AGENDA BILL

Subject: Appeal of the Planning Commission's Determination to Approve Tentative Tract Map 36-235 and Use Permit 2005-09 to Construct a 193-Unit Condominium Hotel Having Lock-off Units Totaling 225 "Keys" with Understructure Parking for 259 Vehicles with Full-Time Valet Parking Services, Spa, Pool and Patio, Meeting Facilities, Restaurant/Bar, Twenty-four Workforce Housing Units, and Associated Landscape Improvements on Five Parcels of Land Totaling Seven Acres.

Applicant: Mammoth Hillside, LLC

Appellant: John Walter, Chair for Advocates for Mammoth

7.2 Height Bonus for On-Site Housing

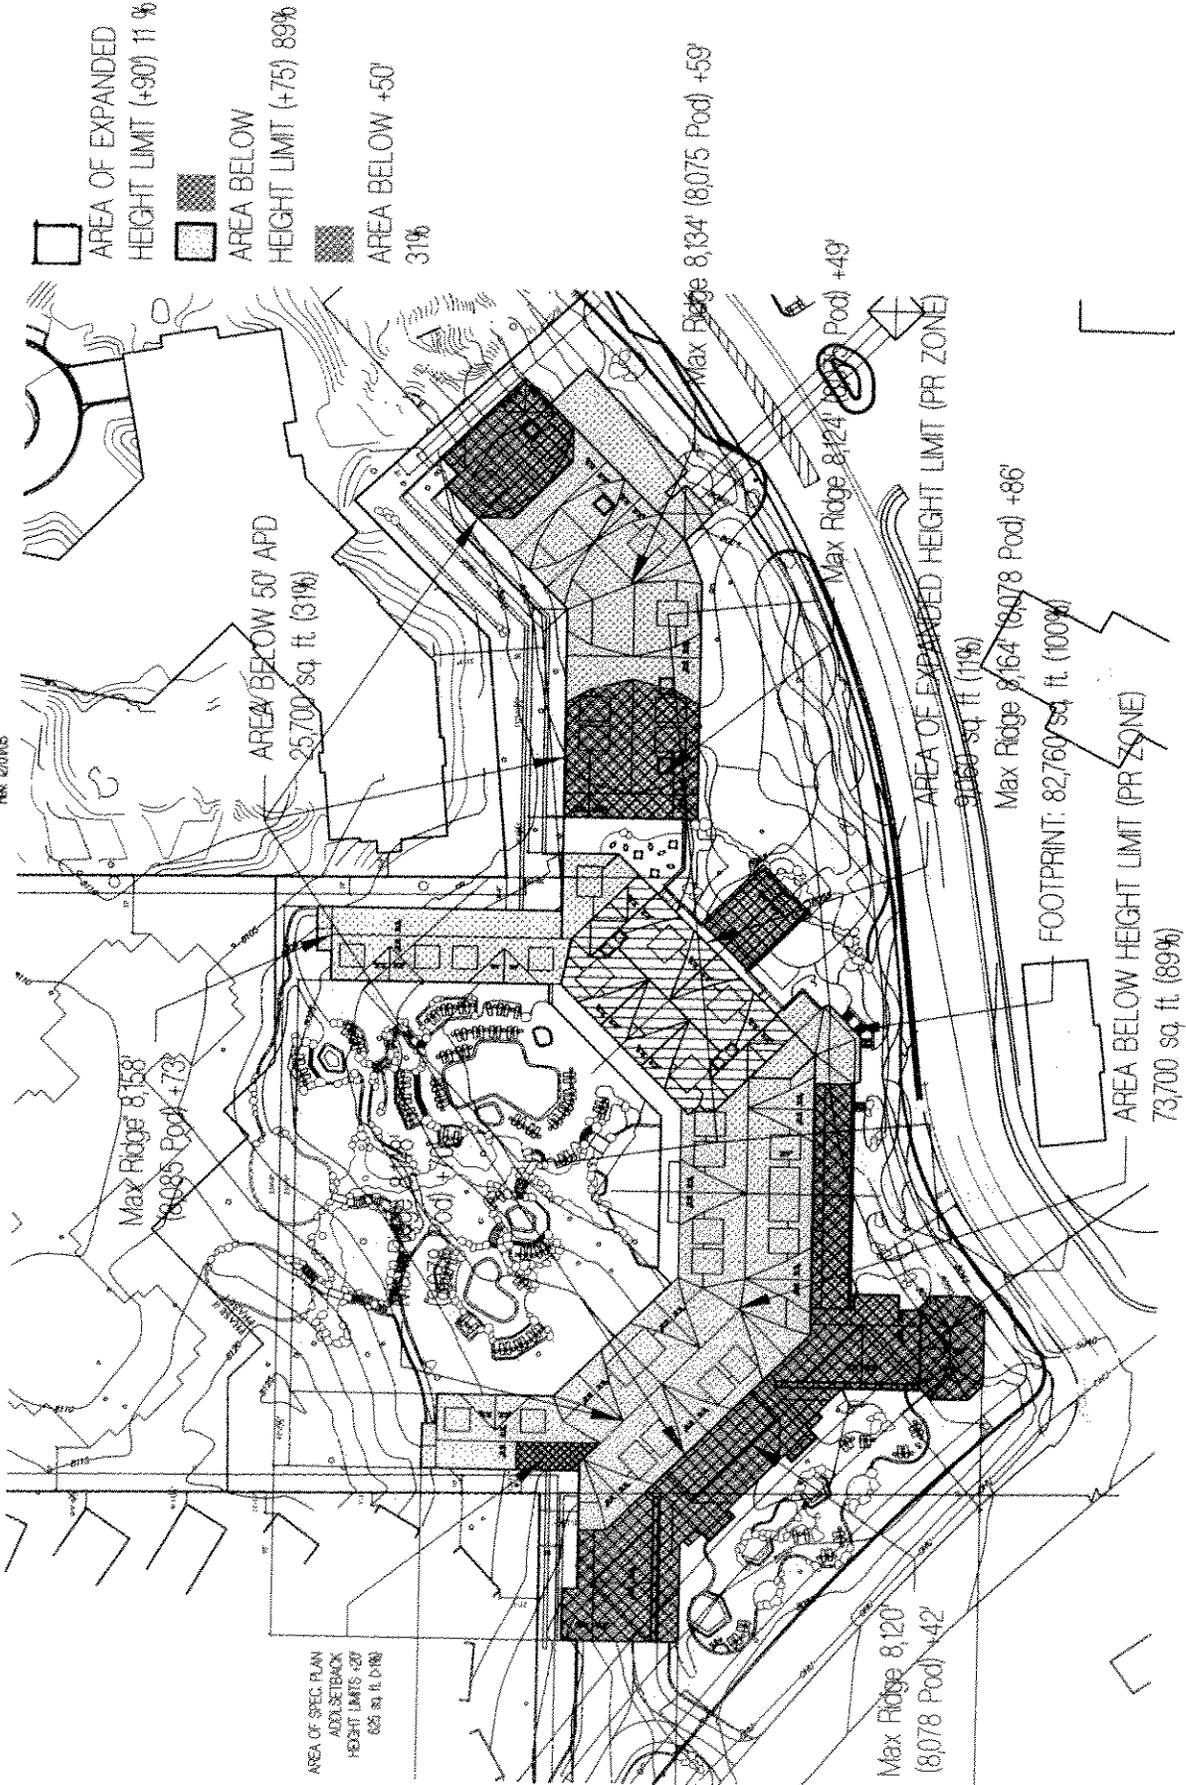
In the same October 28, 2005 correspondence, the TOML staff clarified the applicability of the height bonus in light of their interpretation of buildings that cross two zones above:

2.) Increased Height in the Specialty Lodging Zone for Affordable Housing: As stated in paragraph 1 above (first quote from the correspondence), the height standards for the most liberal district may be applied to this project. In this instance the most liberal district is the PR. The 12-foot height increase for affordable housing is not permitted in the PR district. Therefore, the maximum building height is 75 feet with a maximum projected height of 90 feet and no additional height allowance may be permitted.
